## ADDENDUM #2

### BID NUMBER: 23-13 INTERIOR BUILDING IMPROVEMENTS – SUNBURST YOUTH CHALLENGE ACADEMY IMPORTANT NOTICE

SKETCH NO.  
**SK-1**

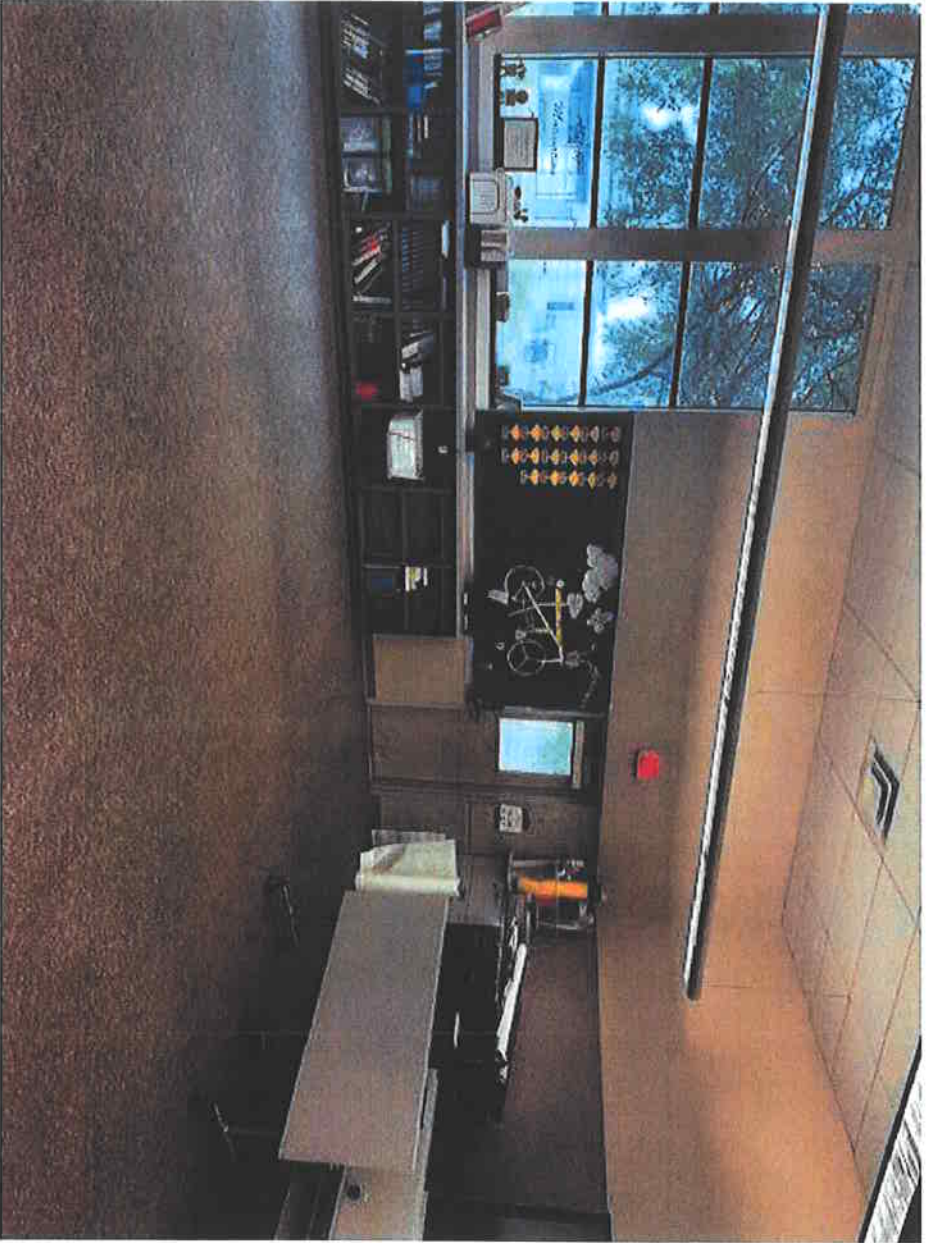
**Response:** See attached pictures SK-2 and SK-3.
7. Question: (N) Transition Strips between (N) Carpet and (N) LVT are required per Spec. Section 09 65 13, para. 2.3; and para. 2.3.C stated, "Profile and dimensions: As indicated on Drawings"; however, the Plan does not include any detail plans. Please provide a detail plan for (N) Transition Strip with its size and profile.

**Response:** See attached threshold detail SK-1.
8. Question: Plan 2/A302 called for Remove and Replace Whiteboard at Building 21. How many whiteboards need to be replaced at Building 21?
